Instruction Sheet Number:  
**99TA509591B**

Description: ELECTRONIC MULTI-FUNCTION TIMER

## MULTI-FUNCTION TIMER SUBSTITUTION

Number: SMB980023

**HK35AA009 Multi Function Timer Typical Wiring**

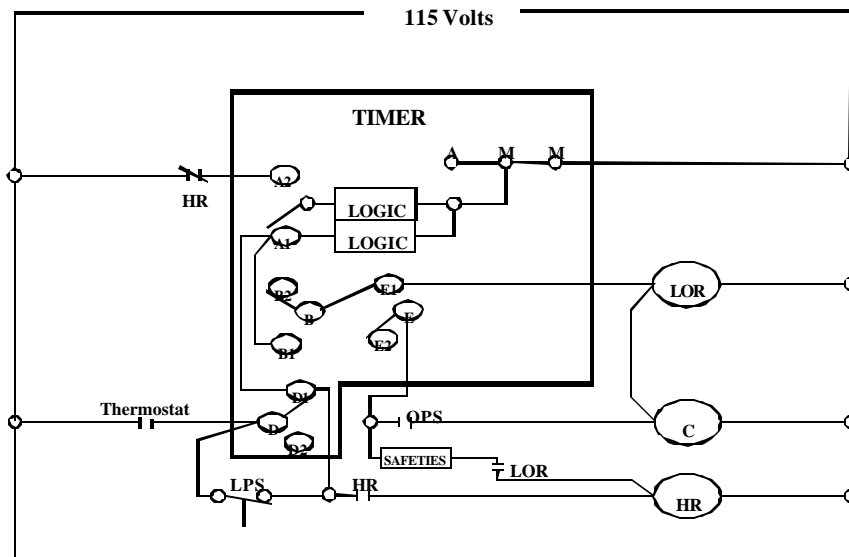
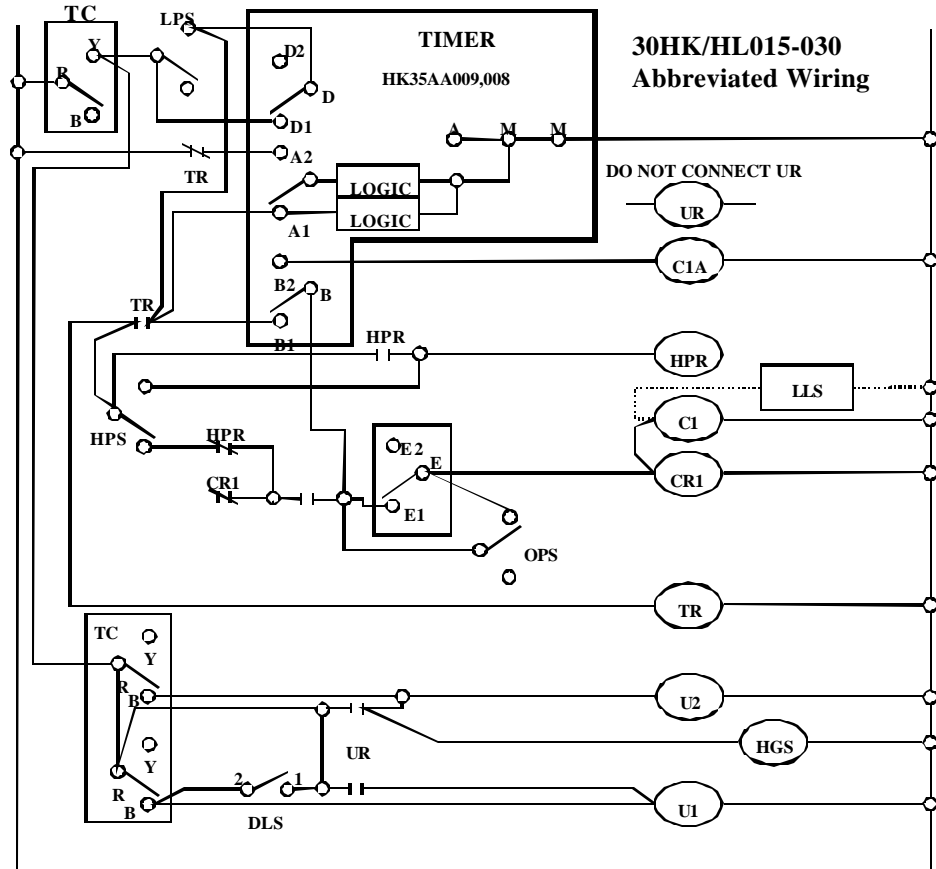
Attached are two wiring schematics for the application of the HK35AA008 and HK35AA009 multi-function timers. The first schematic is for replacing an electro-mechanical timer like an HK25AZ070 or HK25AZ080. The main difference is in the wiring to the "M" terminals. It can also be used when replacing the HK35AA004 and HK35AA005 timers, which in this case is no differences.

The second abbreviated wiring schematic is for replacing an electro-mechanical timer like an HK25AZ070 or HK25AZ080 which is used in a single compressor unit like 30HK/HL015-030. The differences are in the wiring to the "M" terminals AND to the unloader relay(UR). In this case, it is recommended to leave the unloader relay disconnected. With normal step control operation the unit will start unloaded since only the first stage should be energized. Only when all three stages are energized will the unit start fully loaded.

The timer microprocessor program and hardware on the timer board has been changed to compensate for the momentary power interruption. The connection points and all application wiring is identical to the older version timers. The new timer part numbers are HK35AA009(115 volt) and HK35AA008 (230 volt) replacing the HK35AA005 and HK35AA004, respectively.

If lockouts occur as a result of momentary power interruptions, replace the existing timer with part number HK35AA008 for a 230 volt control circuit (used on 60HZ units) or HK35AA009 for a 115 volt control circuit (used on most 60HZ products). RCD is purging all of its old stock in inventory of the HK35AA004 and HK35AA005 timers to assure only the revised timers are available. Remember: When replacing an older style electro-mechanical timer (i.e., Paragon), the new timer does NOT have a physical motor. Connect one wire to one of the “M” motor terminals (as indicated by the unit wiring diagram) and the other wire to the second “M” terminal. These two “M” terminals have the same electrical potential, but do not create a short circuit since the load for the “A” contacts are internal to the electro-mechanical timers (i.e., “A”, “B”, “C”, and “D” terminals of the HK25AZ080). Refer to the attached typical wiring diagram.
